AIP CANADA (ICAO) SUPPLEMENT 43/17

ADJUSTMENTS TO SOUTHERN BOUNDARY OF CYA188 (A)(T) GLEN VALLEY, BRITISH COLUMBIA

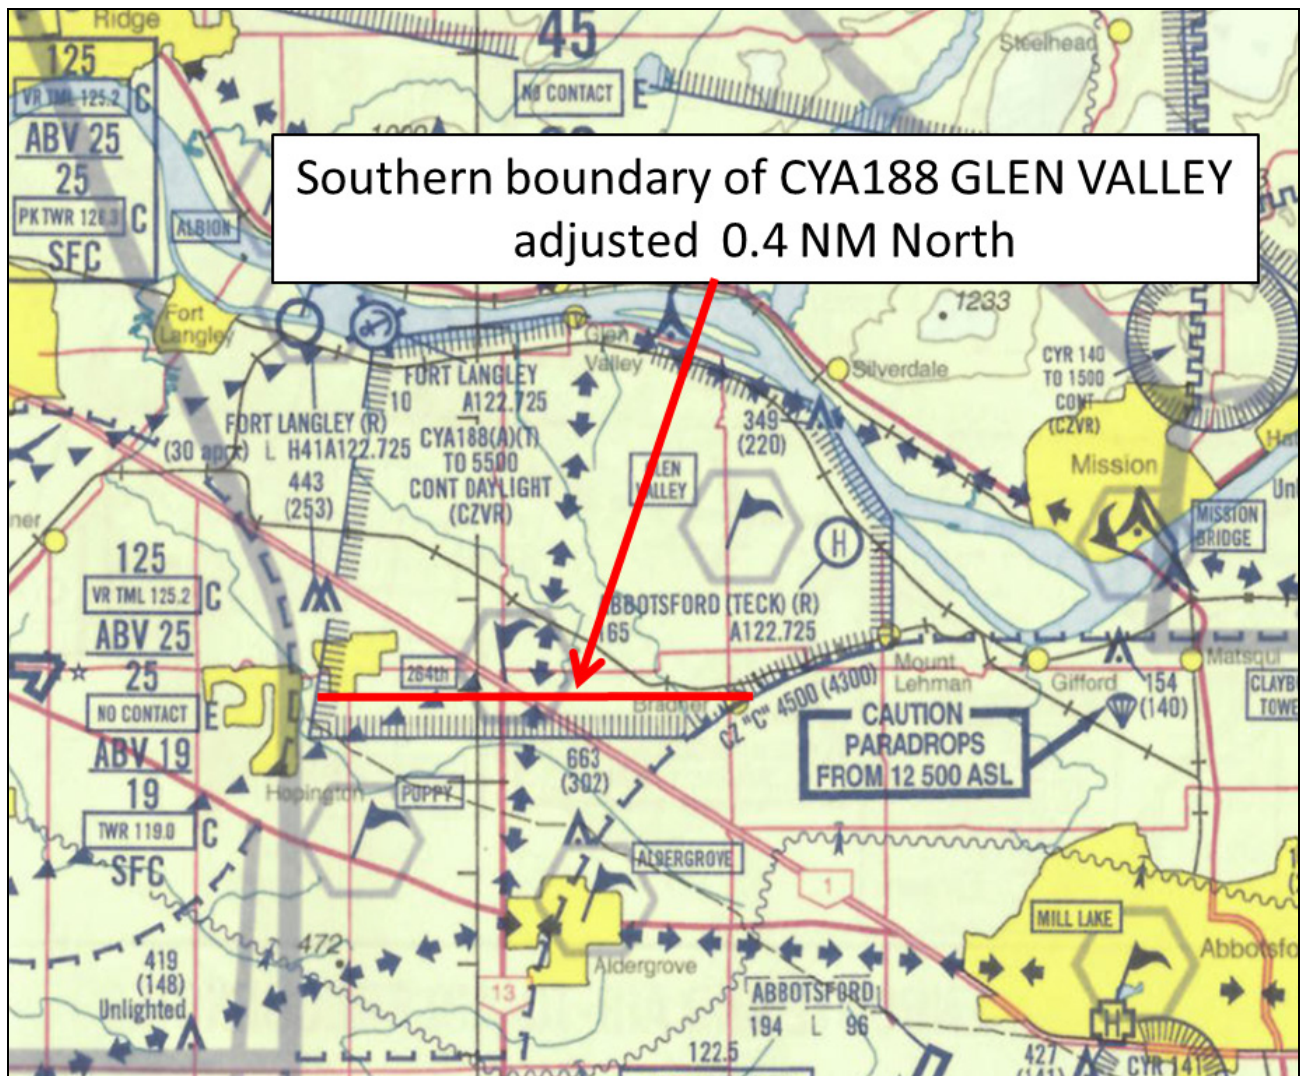
As a result of this review and the application of new IP design criteria, the southern boundary of CYA188(A)(T) Glen Valley, BC must be adjusted 0.4 nautical miles (NM) north (see map sketch below). This adjustment is required so that the Abbotsford airport runway 07 instrument landing system (ILS) and non-directional beacon (NDB) instrument approach procedures will be compliant with the new criteria.

This change takes effect 12 October 2017 at 0901 Coordinated Universal Time (UTC). Refer to this AIP Supplement until the amended Vancouver visual flight rules (VFR) terminal area chart (VTA) (AIR 1901) is available in July 2018.
